**Proposal  
for  
modification  
of  
the satellite boxes**

# Synopsis

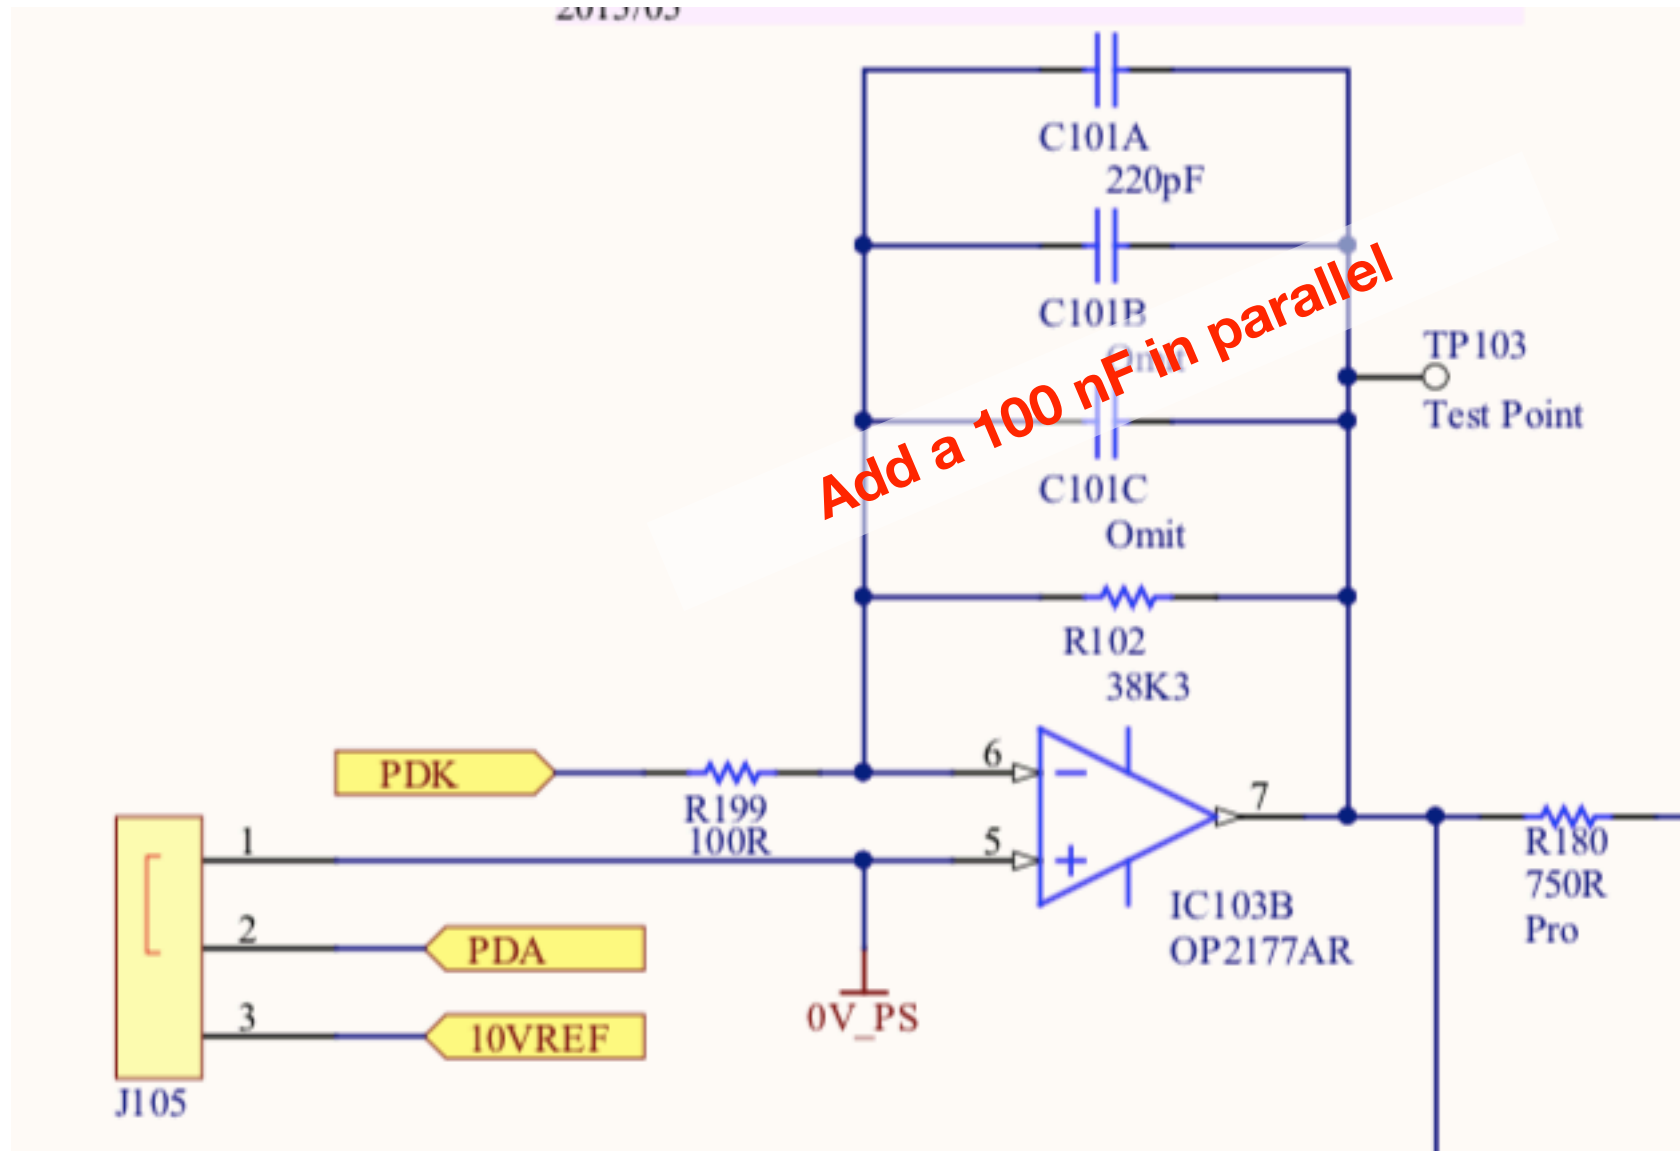
- ✓ The op-amp in the first stage of the sat. box occasionally doesn't properly operate (depending on the cable load). This leads to some high-freq. oscillation.
- ✓ Let's add **a 100 nF cap.** in parallel to the op-amp feedback resistor and do this modification for all the satellite boxes.

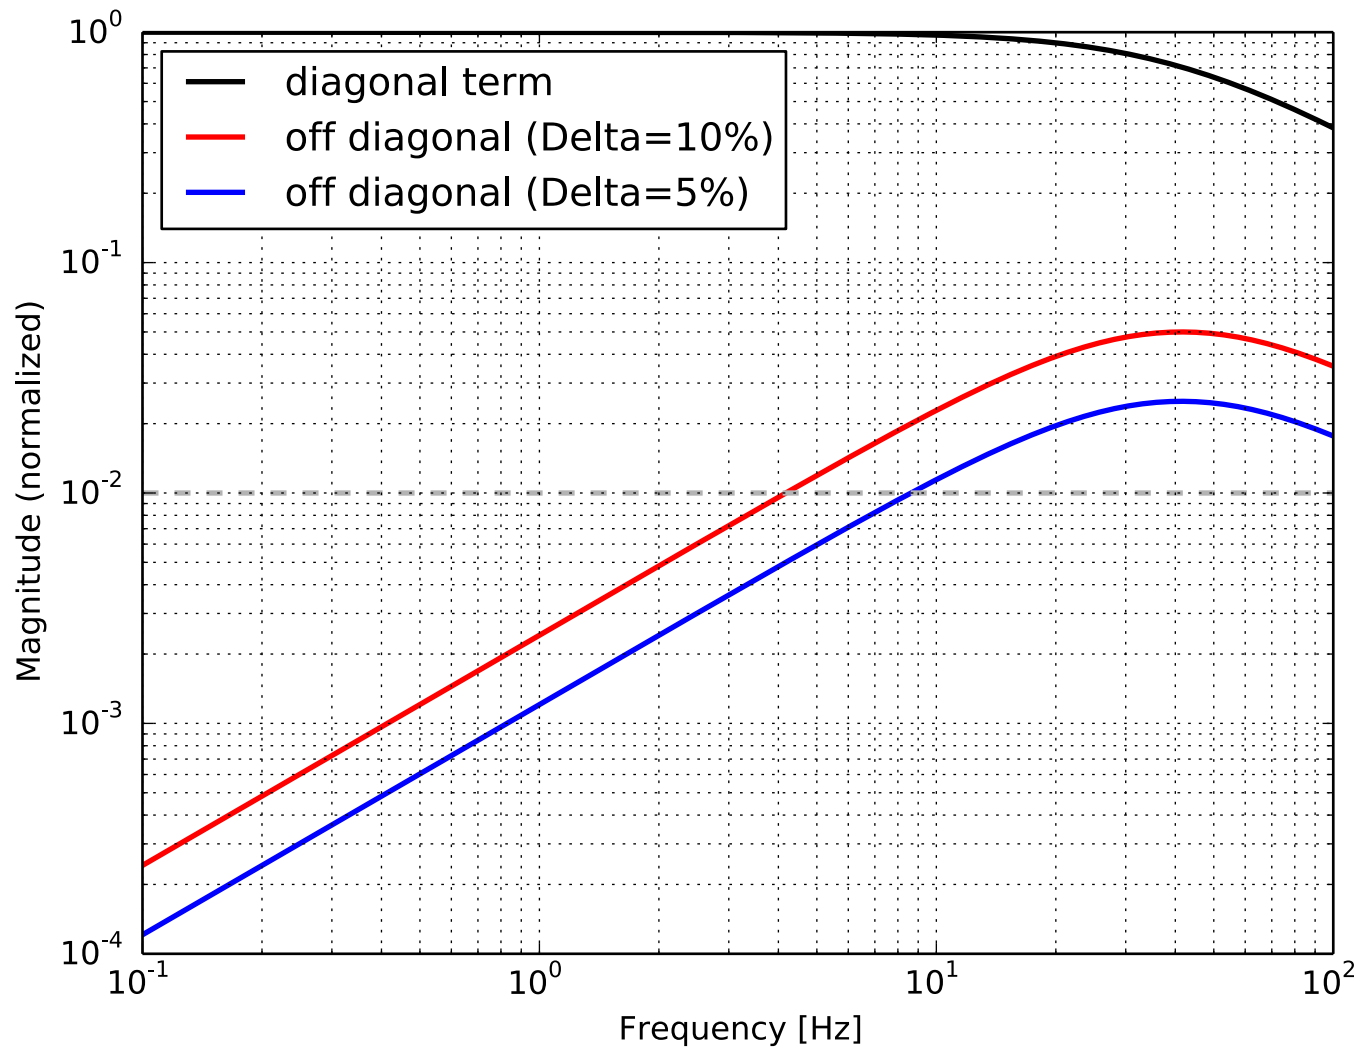
# Precision for the capacitor

10% seems good enough.
